AGENDA ITEM REPORT

ITEM: Review and discussion of Site Plan Application by 9201 West LLC to construct a 6 unit, 3- Story Multi-Family Development to be located at 9201 West Bay Harbor Drive. Enclosed are the Site Plans and the Staff Report prepared by Town Planner Michael Miller.

Subject: **Site Development Plan Application**
 Bay Harbor III Townhouses -5 DU Townhouse Complex
 9201 - 9241 West Bay Harbor Drive
 Bay Harbor Islands Acct. No. SPR22-00002
 MMPA Account No. 01-0702-1114

MMPA recommends the Development Review Committee (DRC) **DEFER** action on the proposed Site Development Plan application at this time to allow the applicant's design team to address the listed comments. The submittal package has several design / Code violation issues, some of the plans are inadequate or missing and a few other items need to be corrected.

Five Townhomes for:
BAY HARBOR III
9201-9241 W. BAY HARBOR DRIVE
BAY HARBOR ISLANDS FL. 33154
FLOOR PLAN UNIT 1

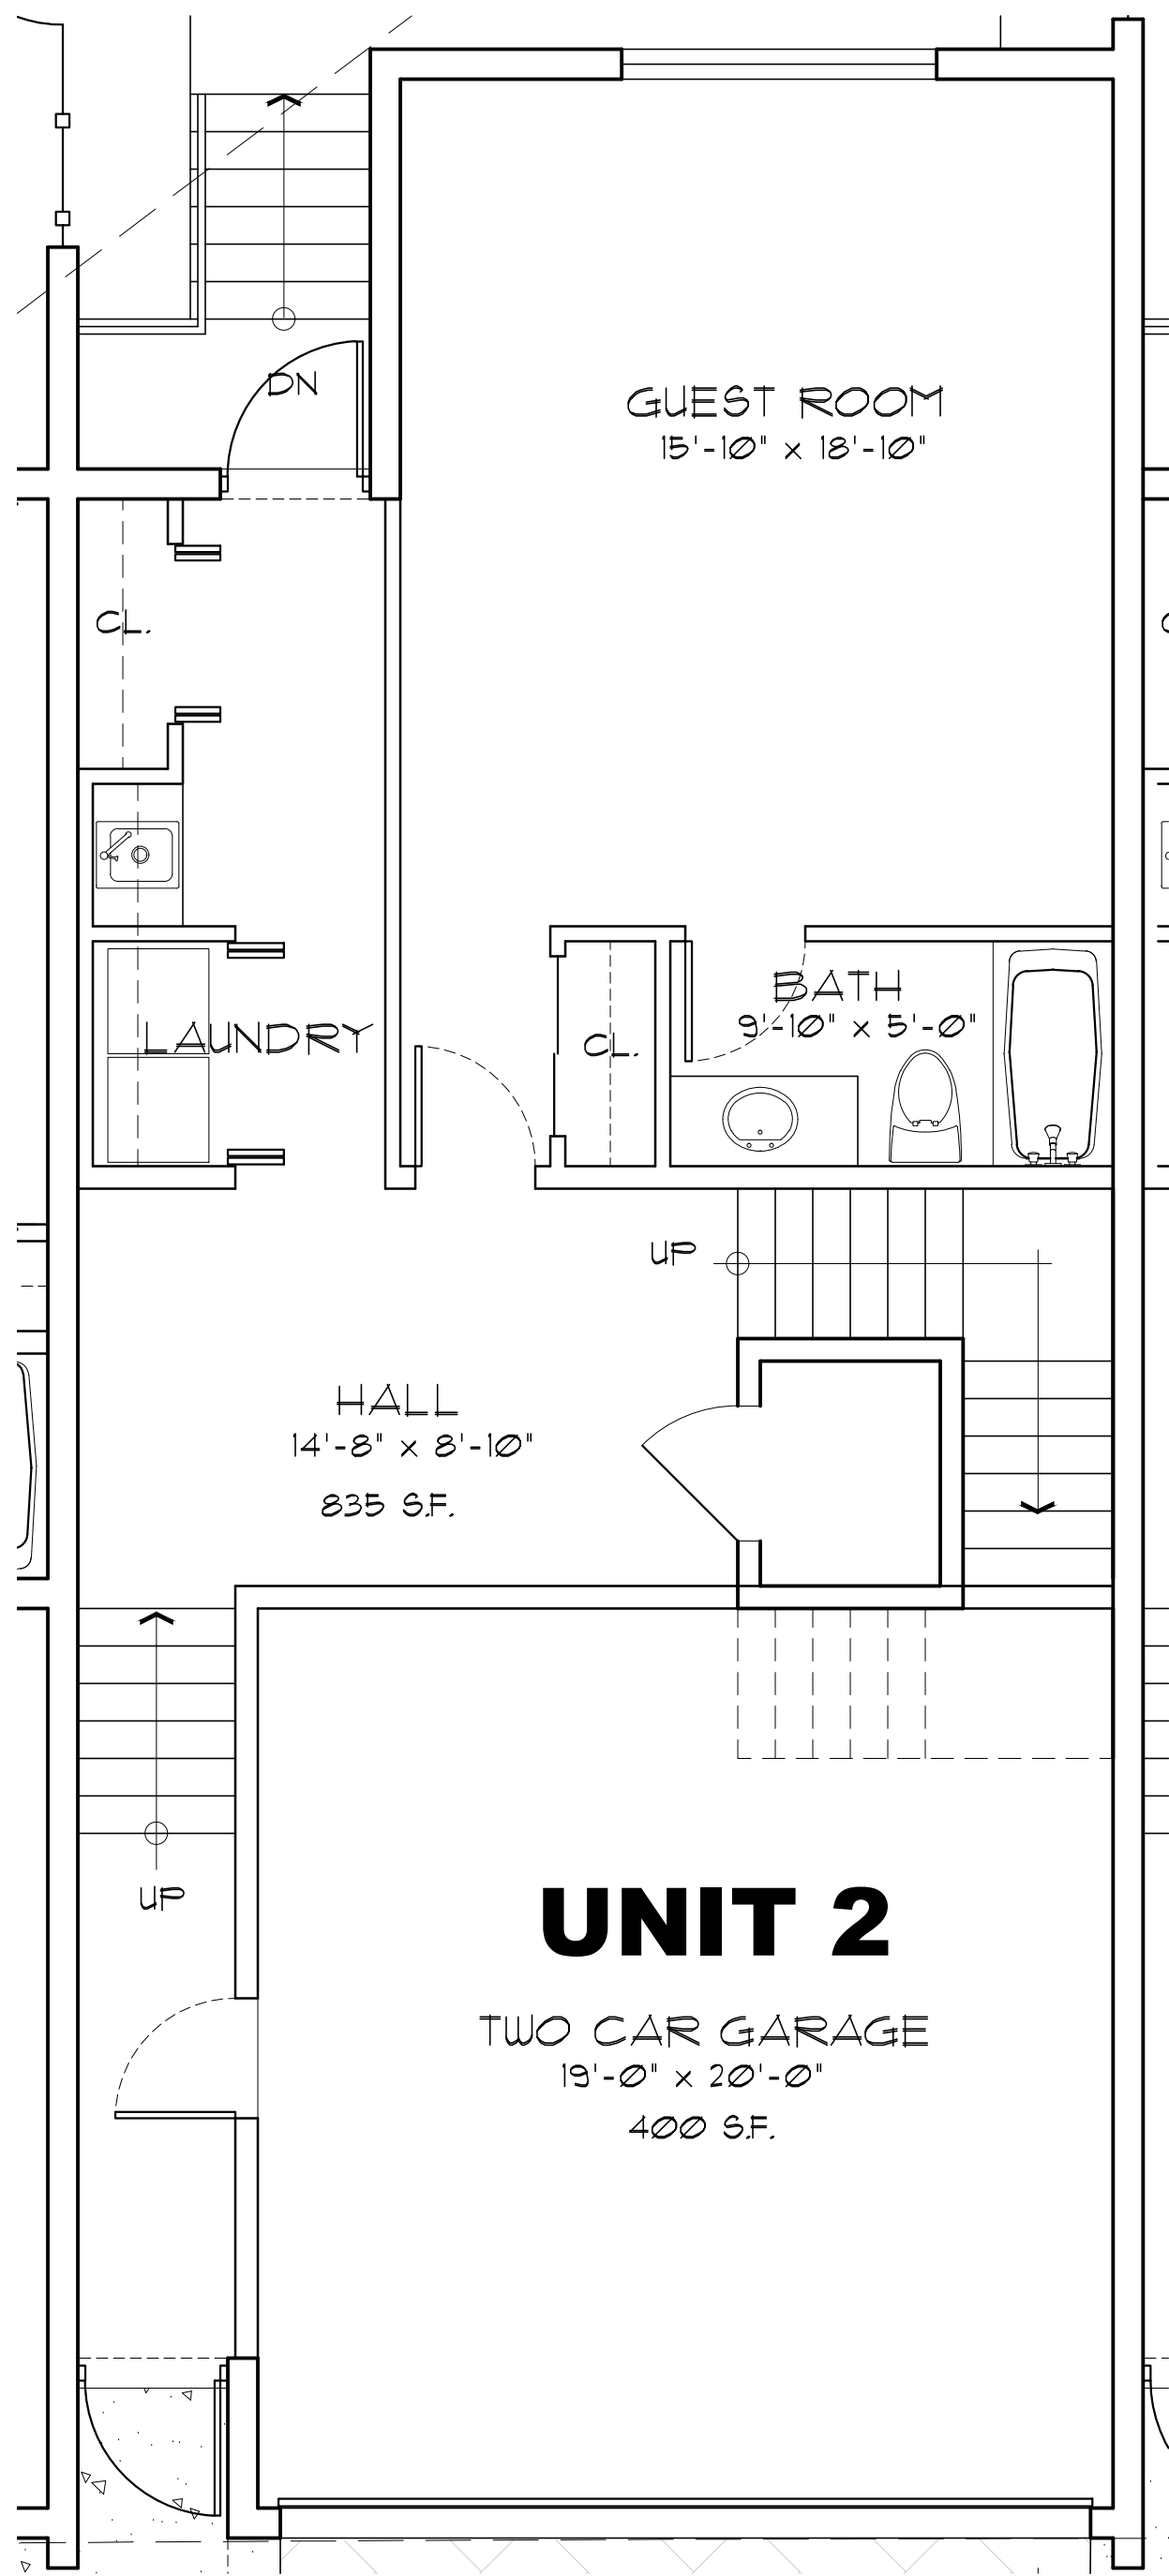
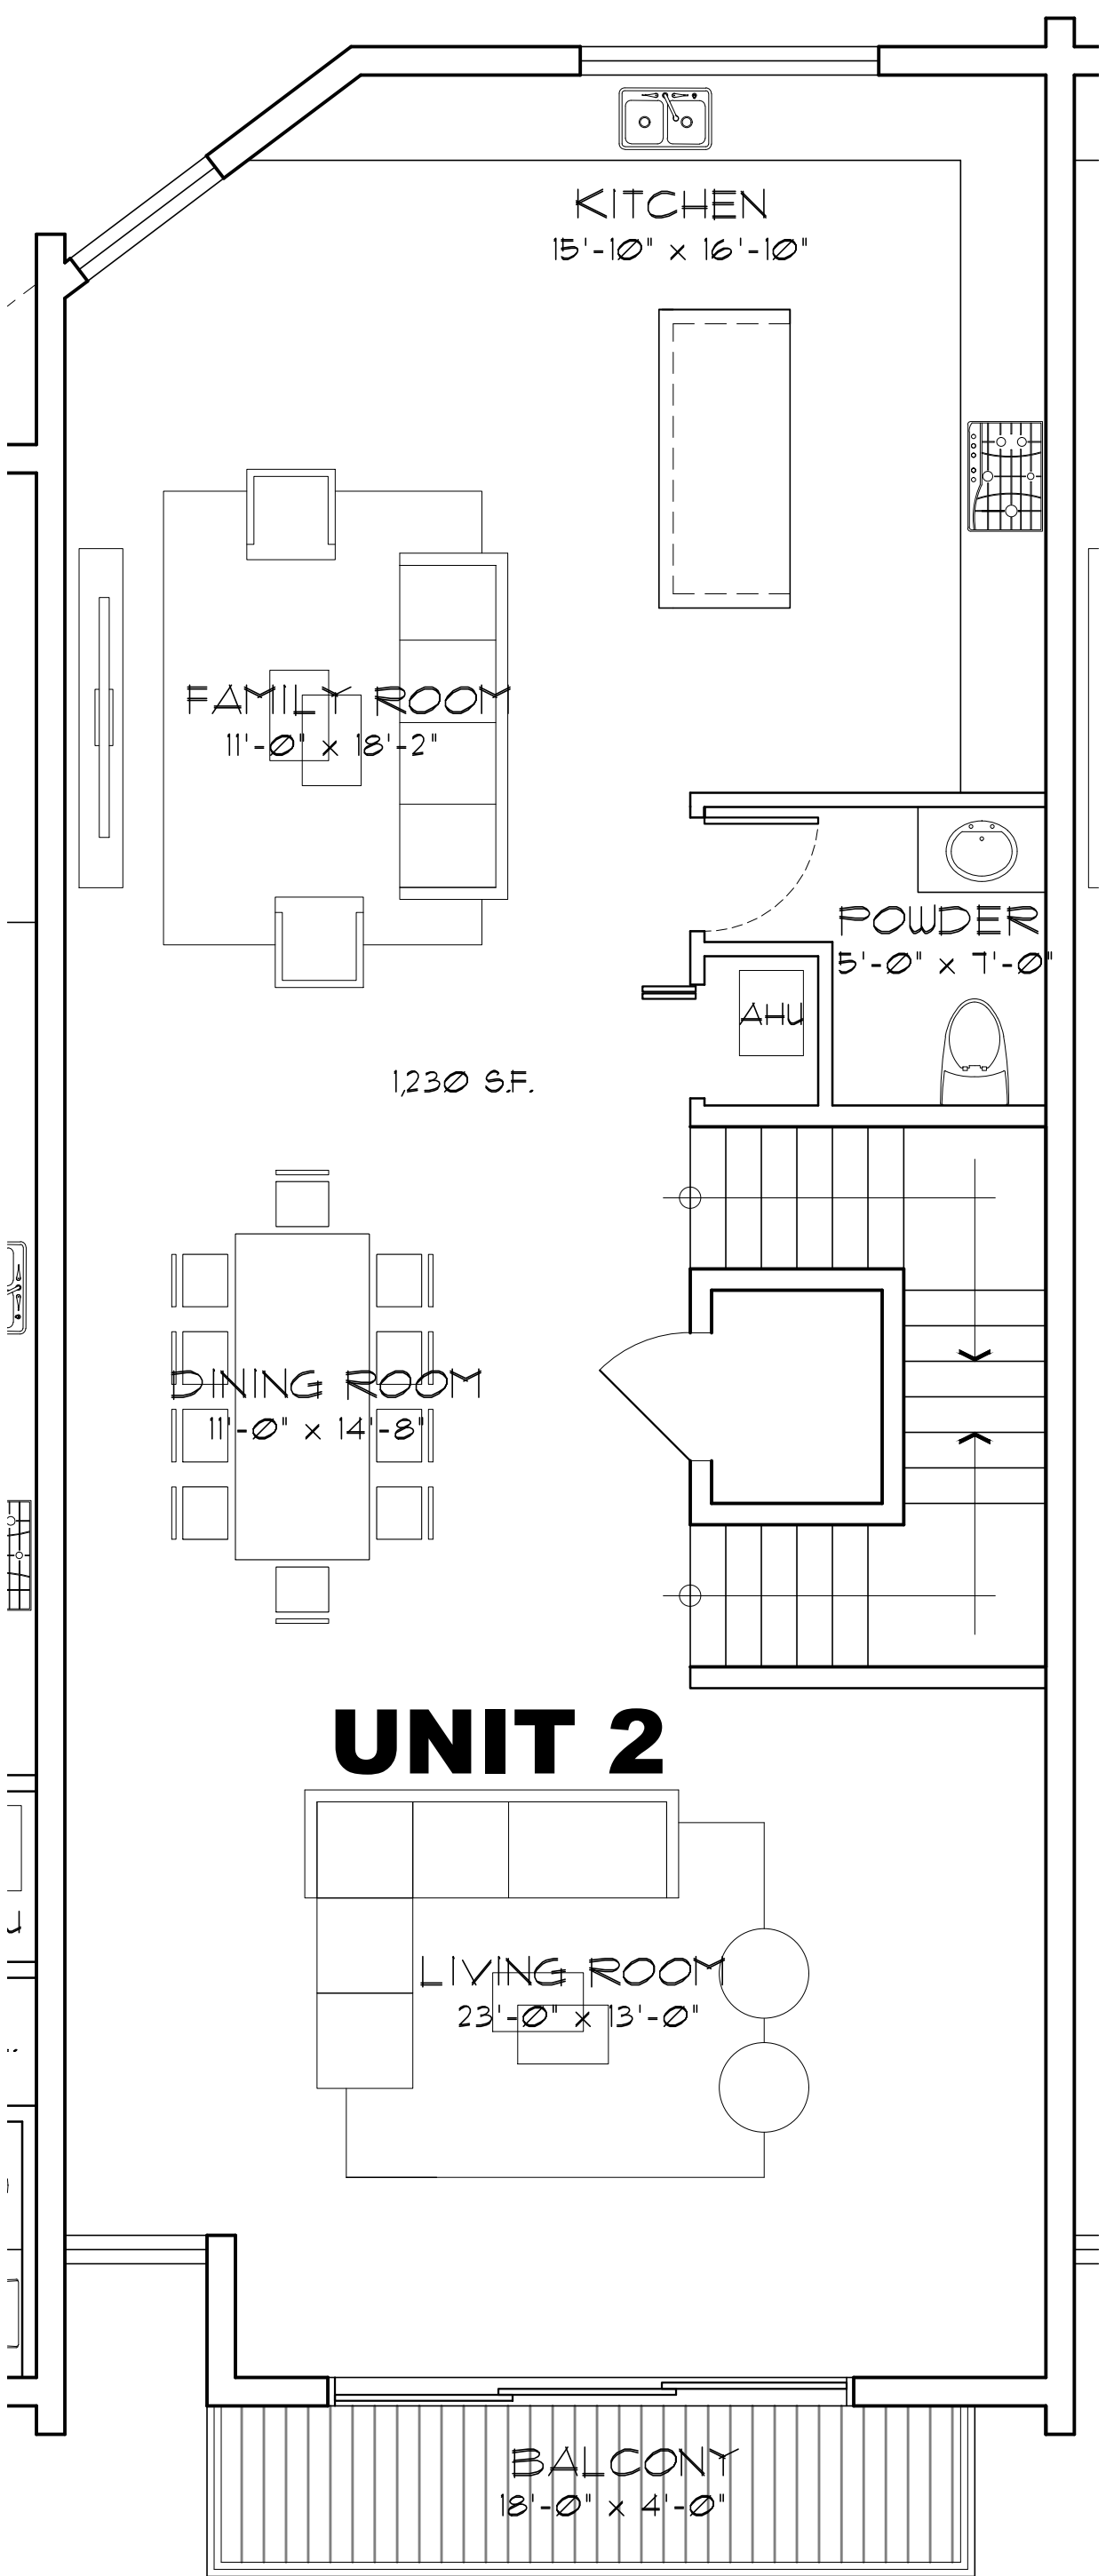
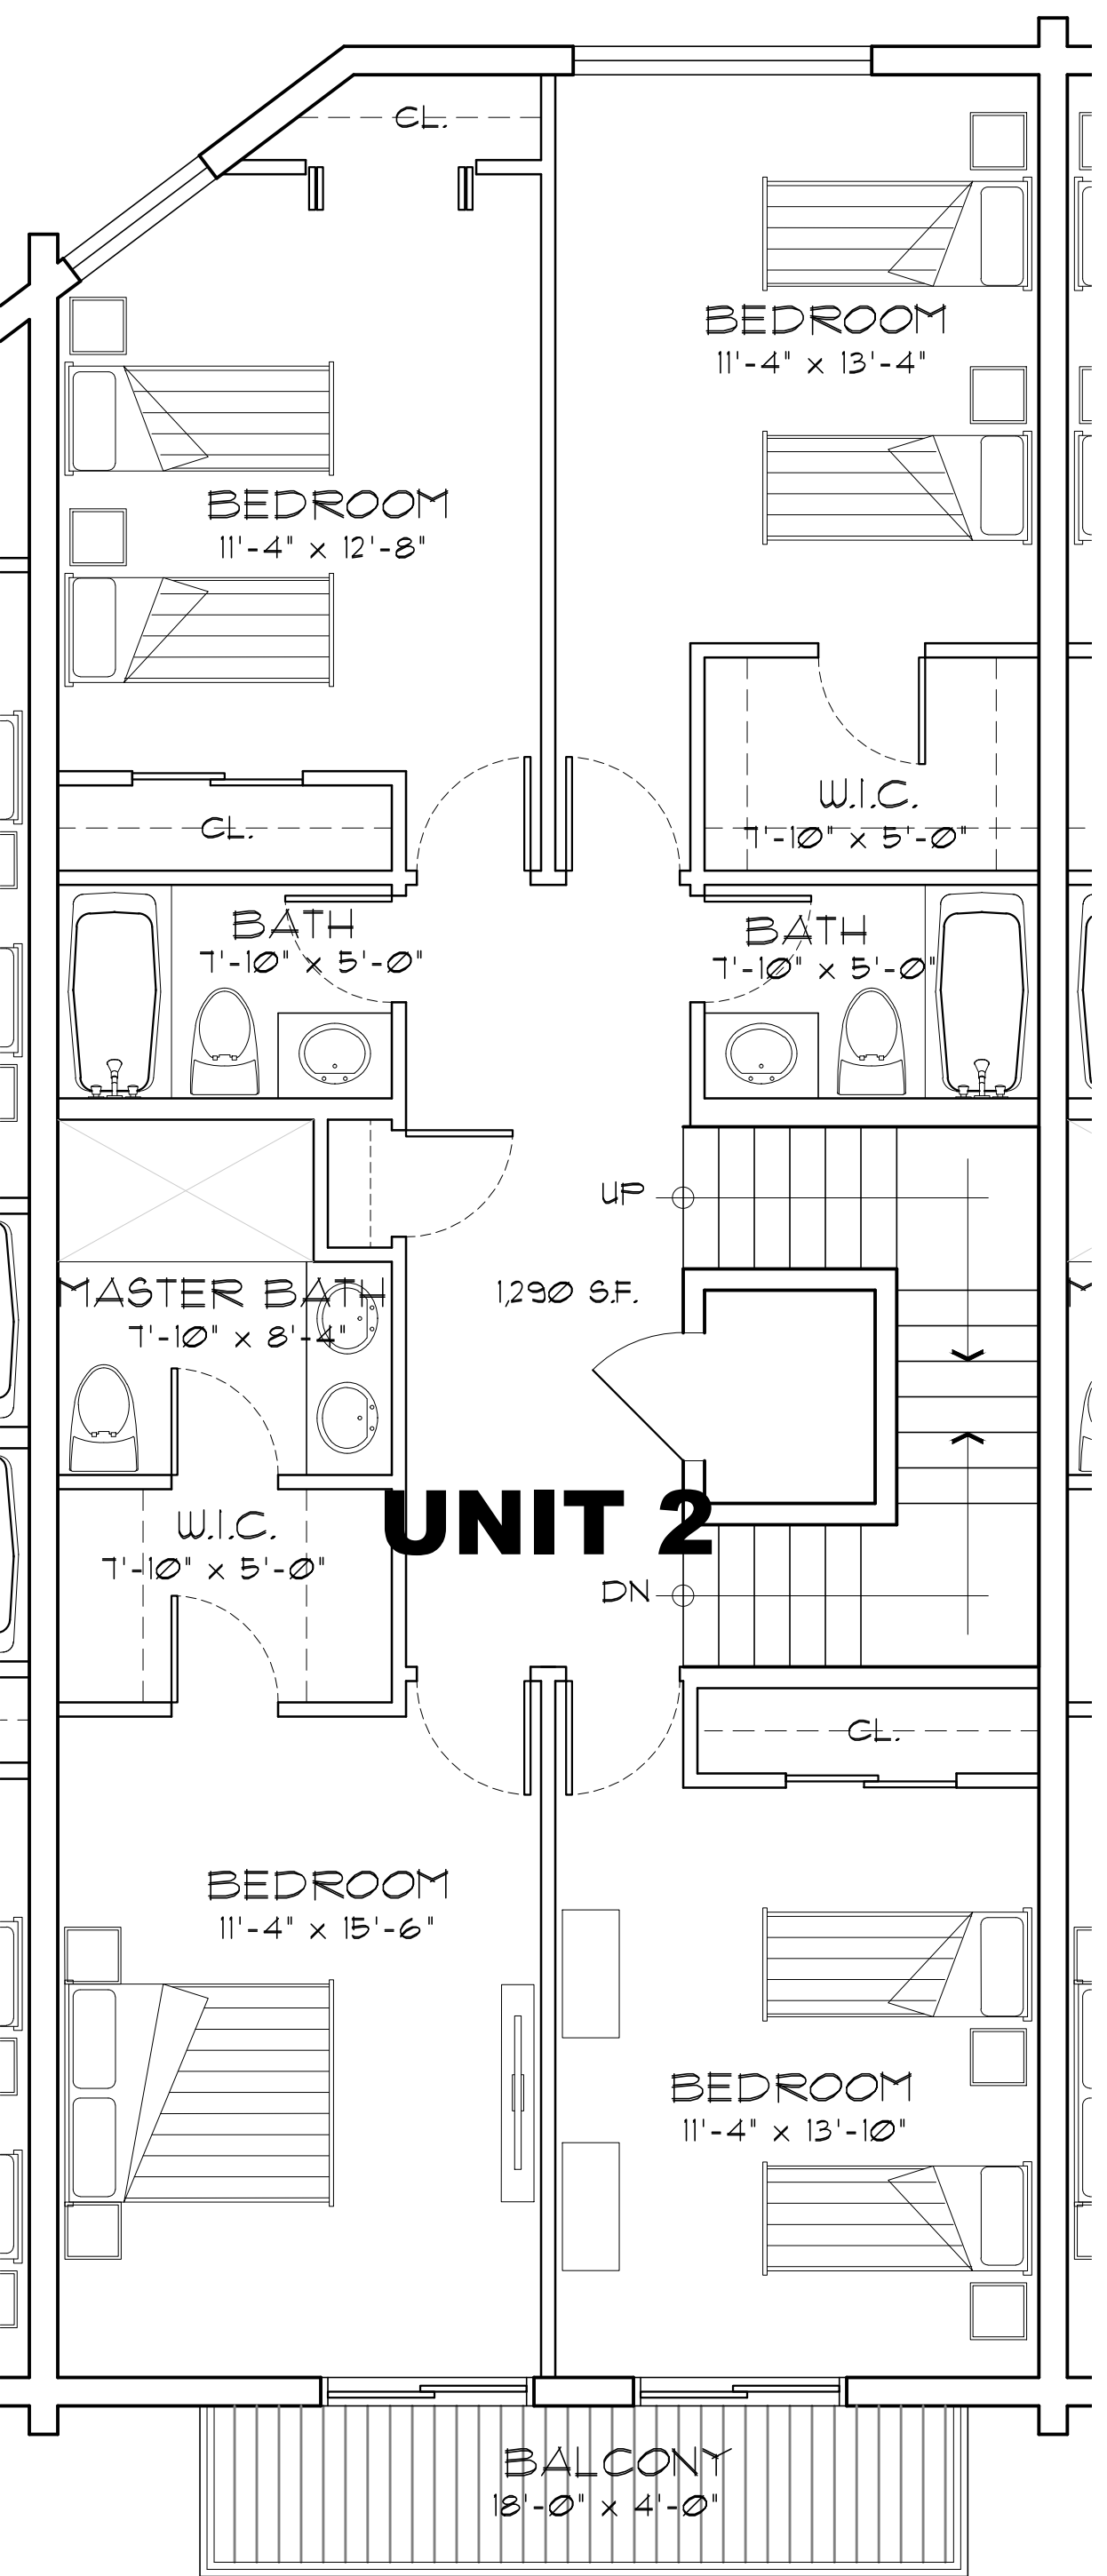
15. On Sheet A-5 Roof Deck Plan a bathroom is shown. Please provide a detail showing the height of the bathroom. Also provide a detail / information on the proposed screening around the roof A/C units. Please provide the height, screen material and color.
